## INTRODUCTION

Since the introduction of the THM 440-T4 Transaxle in April, 1984, there have been many major engineering design changes. These changes have affected nearly every part used in the THM 440-T4. This Update Handbook will explain each change, the parts affected by the change, and any parts interchangeability problems created by the change.

### THM 440-T4 PUMP INFORMATION

Figure 36

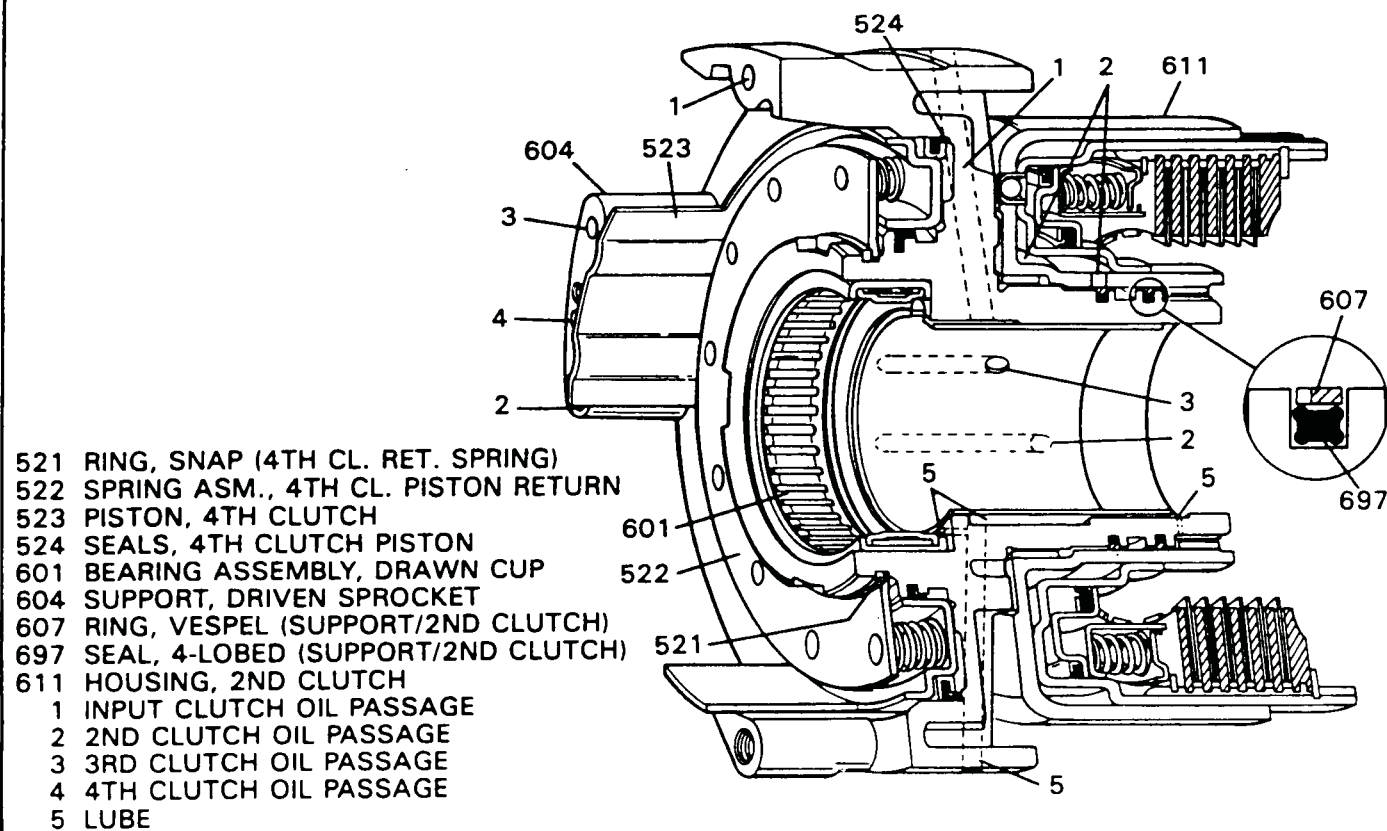
Change: "Vespel" Sealing Rings and 4 Lobe Ring (See Figure 36).

This change, also initiated in the 1987 models, related to 2nd clutch durability and was on the driven sprocket support. The 84-86 models have large steel, hook joint, sealing rings to feed the 2nd clutch. In 1987 models the steel rings were replaced with "Vespel" (Plastic), step joint, sealing rings, that have tabs on them to prevent them from spinning in the driven sprocket support (See Figure 37). This made it necessary to machine slots in the driven sprocket support, to accept the tabs on the "Vespel" rings. There is also a special 4 lobe ring that goes in the ring groove under the "Vespel" ring, and acts as an expander for the "Vespel" sealing rings (See Figure 36).

- 1) Driven Sprocket Support - Slots added to accept tabs on the "Vespel" sealing rings, and ring grooves machined deeper to make room for the 4 lobe ring (Expander).
- 2) No. (697) 4 lobe ring acts as expander for (607) "Vespel" sealing ring (See Inset, Figure 36).

Figure 40

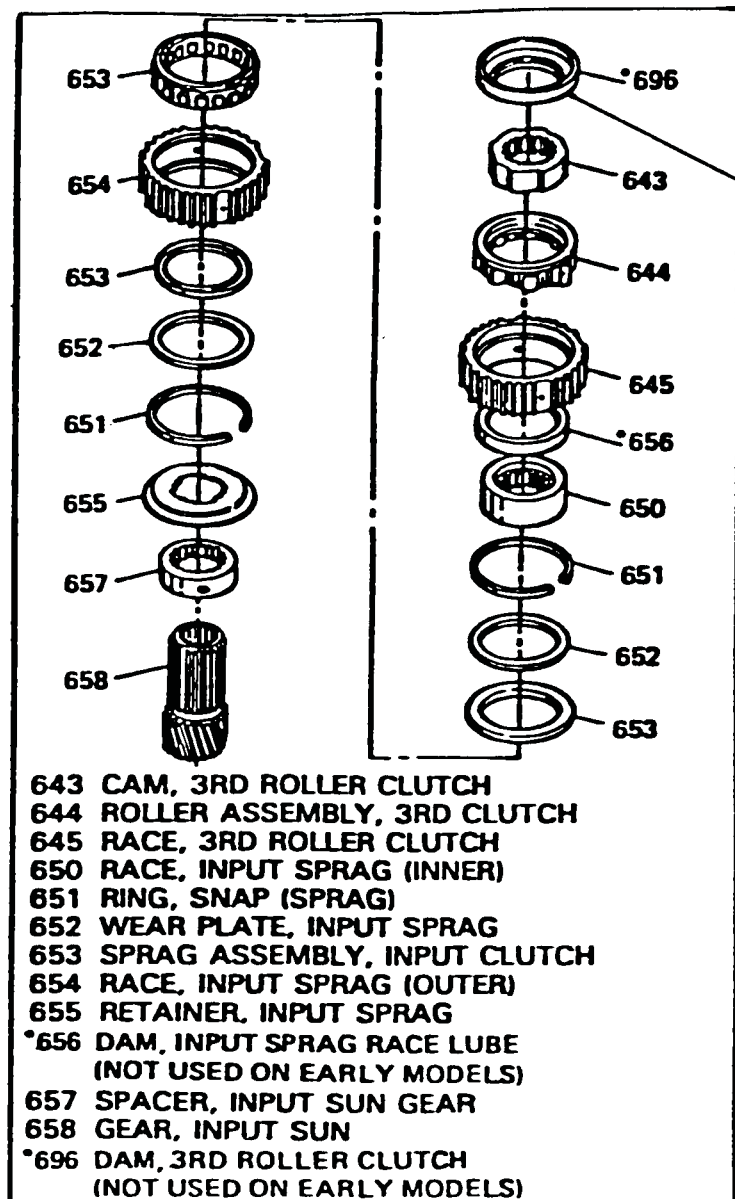
Change: Addition of "Oil Dam" to 3rd roller clutch (See Figure 40).

Figure 42

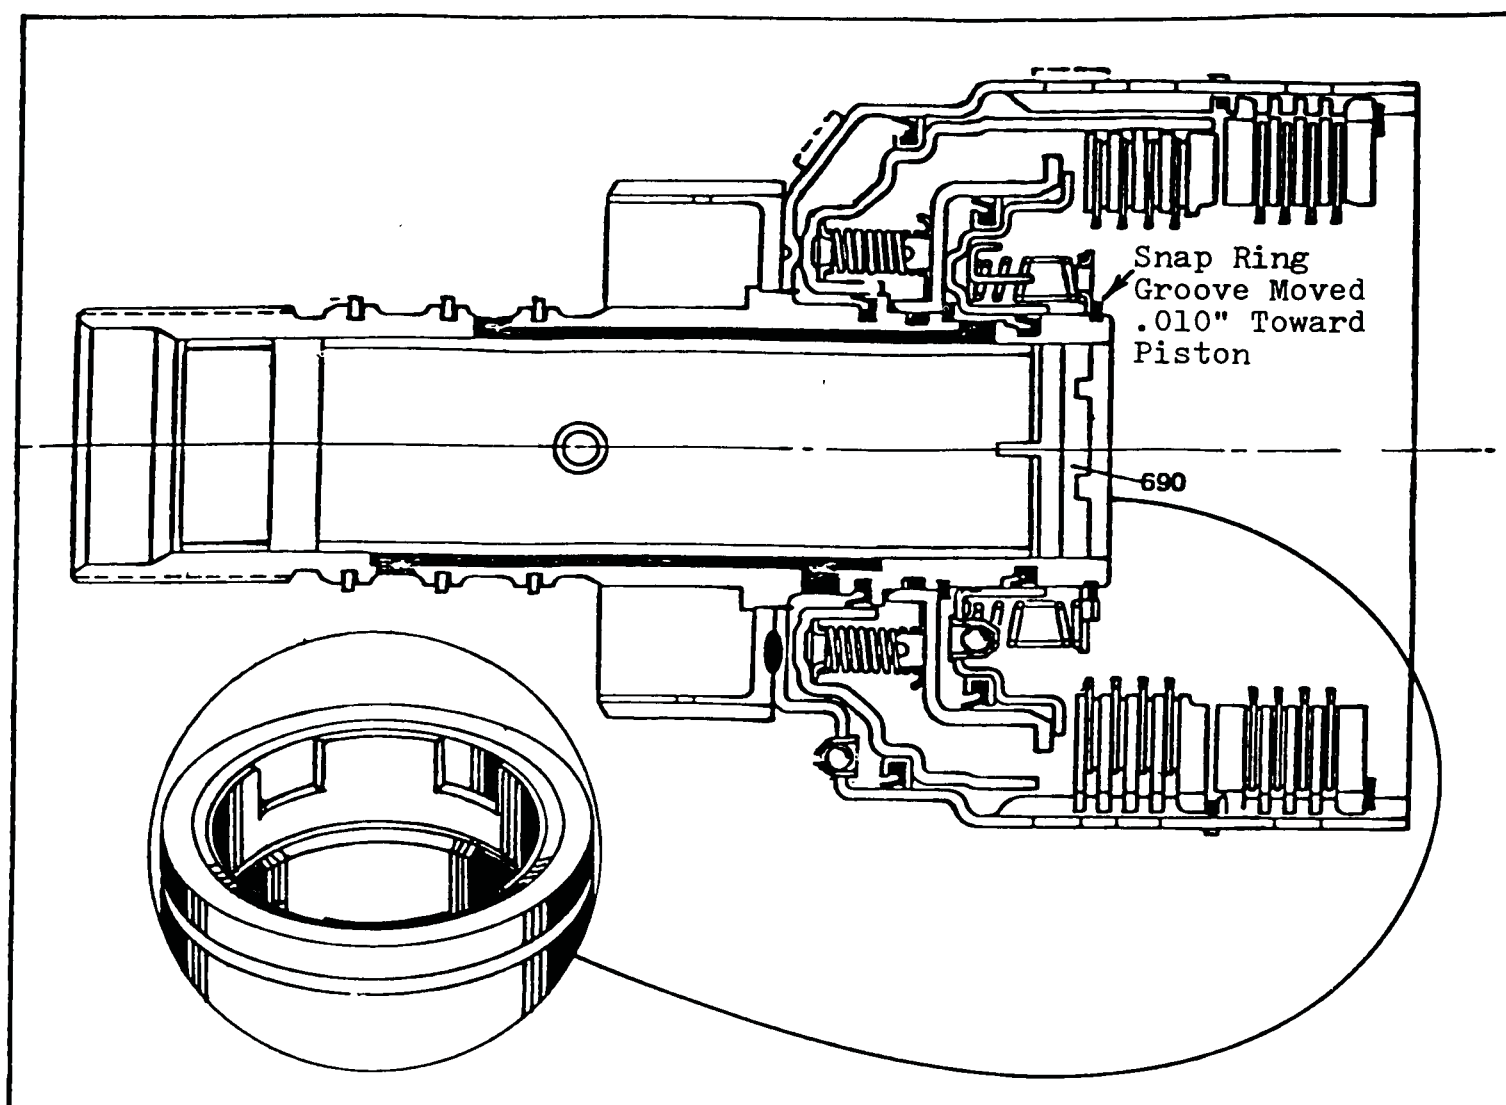
- 1) 3rd Roller Clutch, Outer Race - Modified to accept the added oil dam.
- 2) 3rd Clutch Return Spring Assembly - Tabs removed from top of return spring assembly, because of interference with added oil dam (See Figure 41).
- 3) Input Housing - Snap ring groove moved .010" toward the 3rd clutch piston. This was done to move the 3rd clutch return spring assembly an additional .010" away from added oil dam for added clearance (See Figure 42).

NOTE: If new input housing is purchased, be sure to remove (690) sleeve from old input housing and reinstall in the new input housing, as it does not come with the new input housing (See Inset, Figure 42).

This (690) sleeve has notches in it to accept the tangs of the "Top Hat" washer to prevent the washer from spinning in the housing (See Inset, Figure 42).

Figure 44

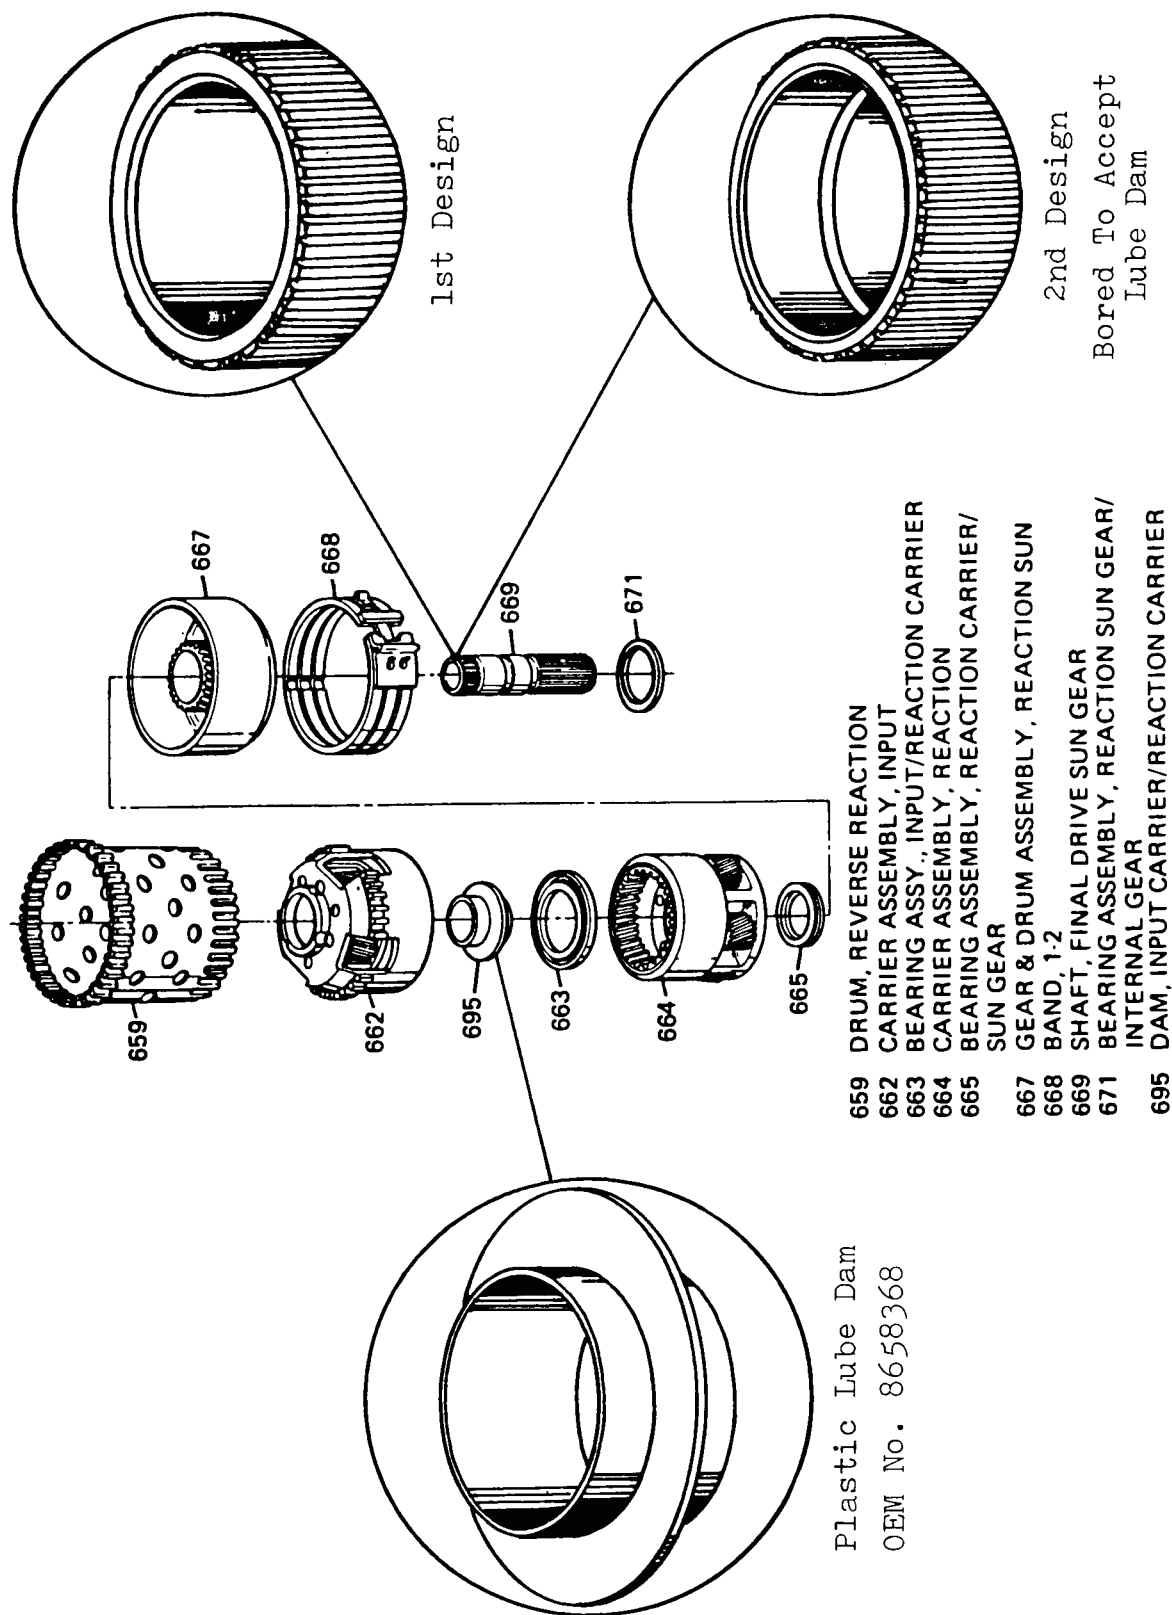
Change: Addition of plastic lube dam (695) between carriers.  
(See Figure 44).

- 1) Input Carrier(662) (Figure 44) - Bored larger on inside diameter to accept added lube dam.
- 2) Output Shaft(565) (Figure 45) - Machined shoulder on output shaft to accept added lube dam (See Inset, Figure 45).
- 3) Final Drive Sun Gear Shaft(669) (Figure 44) - Inside diameter bored larger on one end to accept added lube dam. (See Inset, Figure 44).

Figure 46

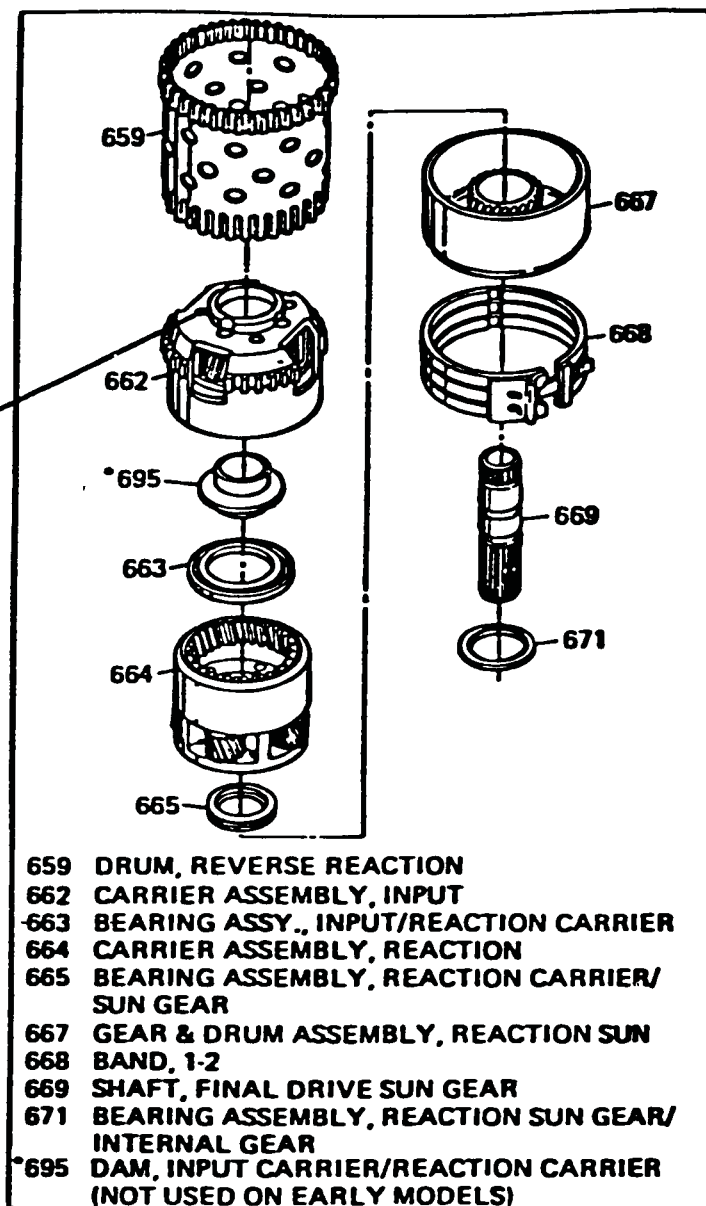
- 1) Input Sprag Assy(653) - Length of sprags increased by .095" and redimensioned end plates.
- 2) Outer Race(654) - Wider by .050".
- 3) Inner Race(650) - Wider by .142".
- 4) Retainer(655) - Shallower by .065" (See Figure 49).
- 5) Spacer(657) - Thinner by .142" (See Figure 49).
- 6) Input Carrier(622) - Shoulder machined down to shorter dimension (See Figure 46).

CAUTION: The input carrier must be replaced or modified as per specifications in Figure 46. If not replaced or modified, an interference will result and damage to the transaxle. The lip protruding on top of the input carrier must be machined to meet the dimension shown in Figure 46. Extra care must be used in the machining process, as the torrington bearing will not come out of the input carrier.

Figure 51

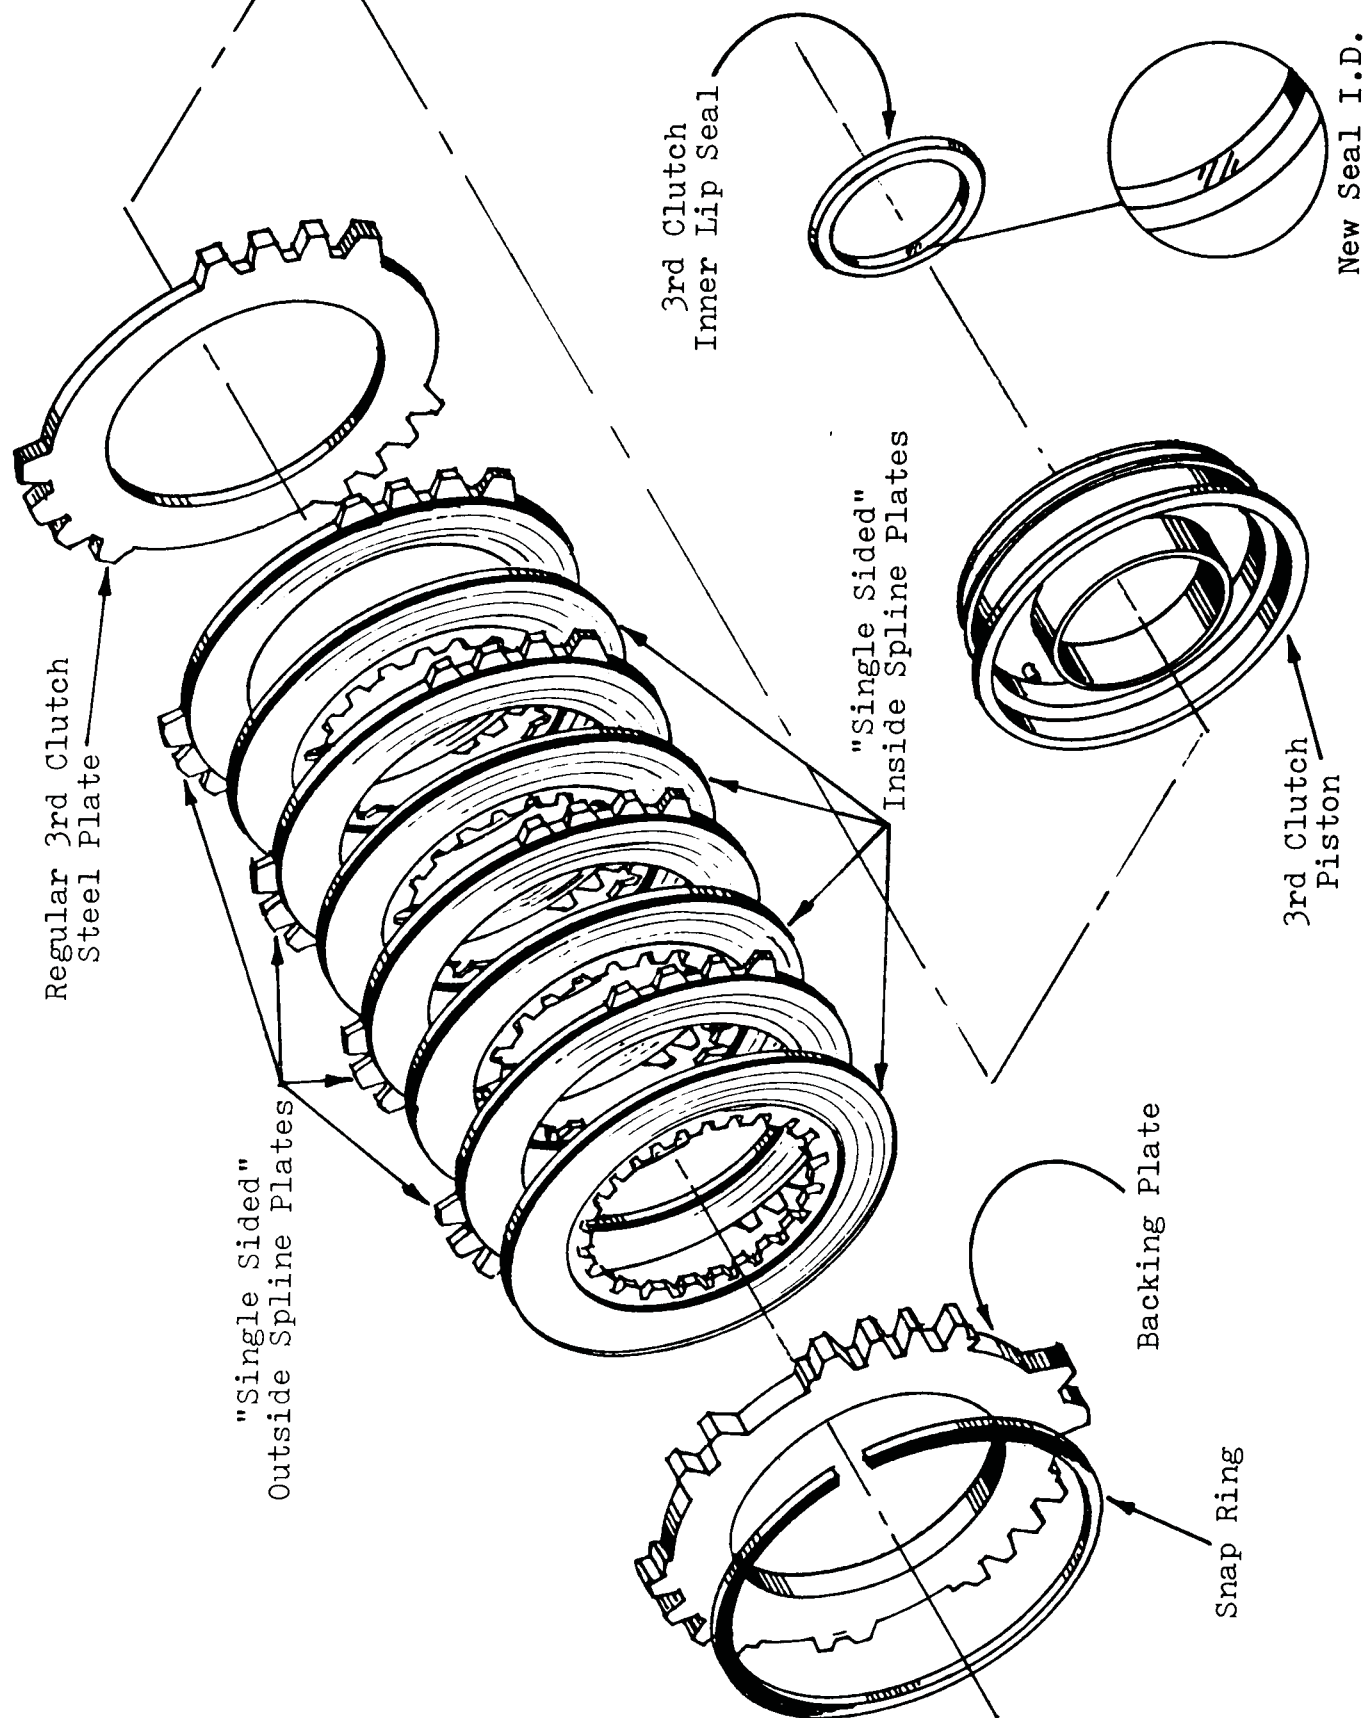
1st Change: Single Sided 3rd Clutch Plates - Lining on one side only both inside and outside spline plates (See Figure 51).

Will retro fit backwards, and is recommended. New OEM Part No. is 8662673 on the new 3rd clutch lip seal. For positive identification of the new seal, check for hash marks on inside diameter of lip seal (See Inset, Figure 51). For difference in profile compare Inset "A" and "B" in Figure 52.

Figure 52

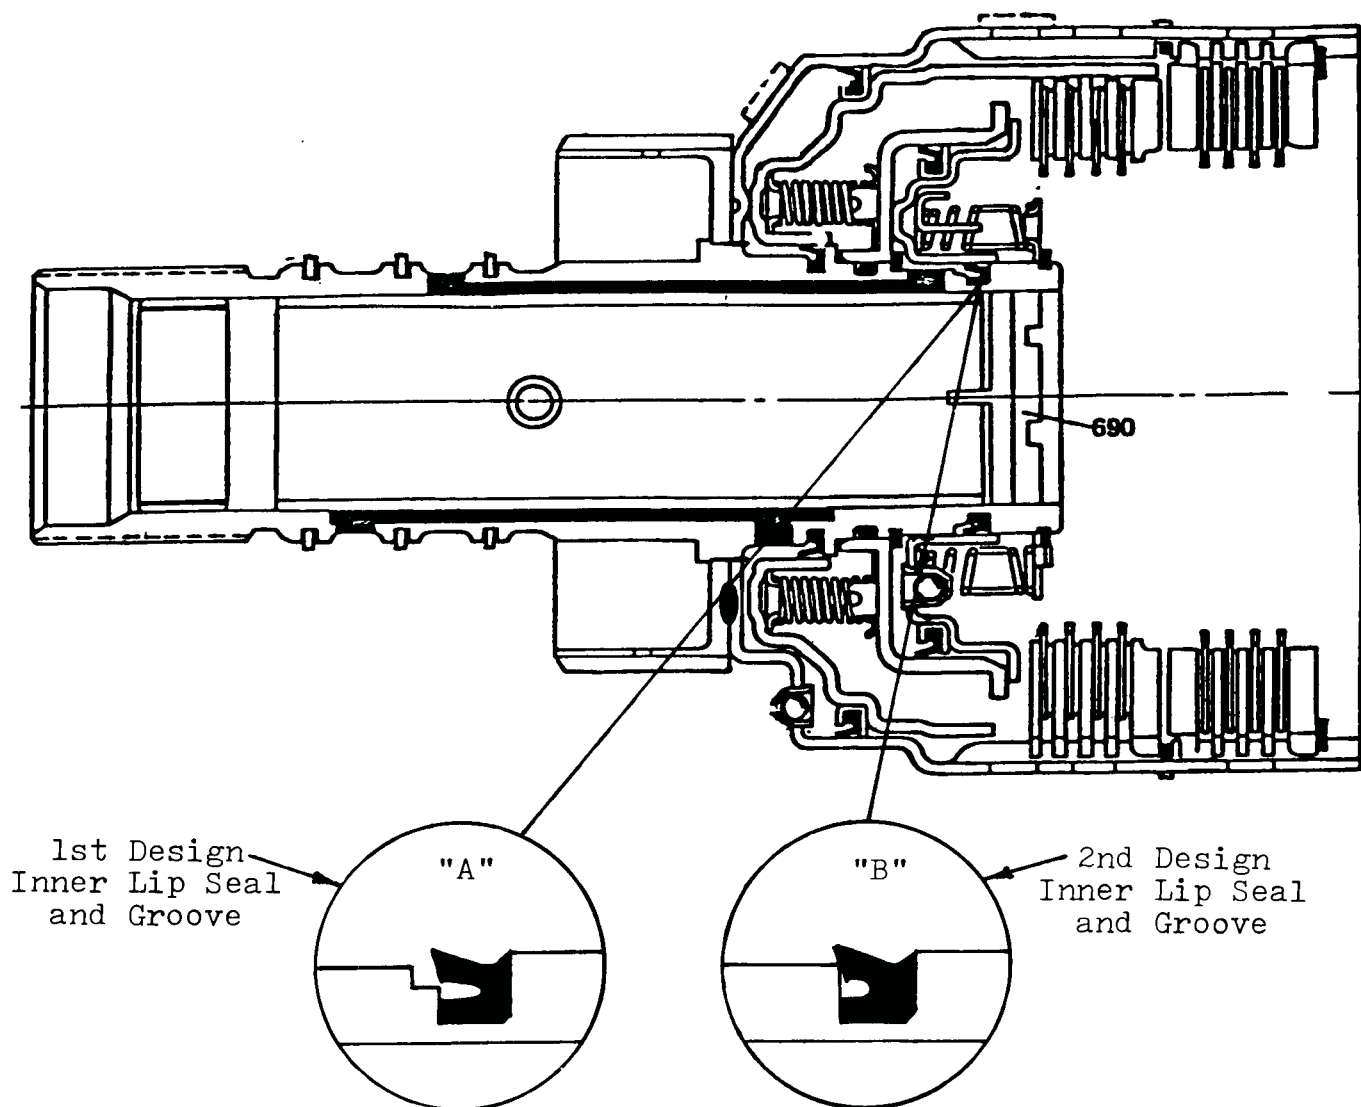
- 1) 3rd Clutch Inner Lip Seal - Thicker profile to help prevent seal from rolling (See Inset, Figure 52).

3rd Change: Input/3rd Clutch Housing - Revised 3rd Clutch Inner Lip Seal Groove (See Figure 52)

- 1) Input/3rd Clutch Housing - One machining process eliminated in groove for the 3rd clutch inner lip seal, which provided more support for the lip seal to prevent it from rolling.  
(Compare Inset "A" and "B", Figure 52).
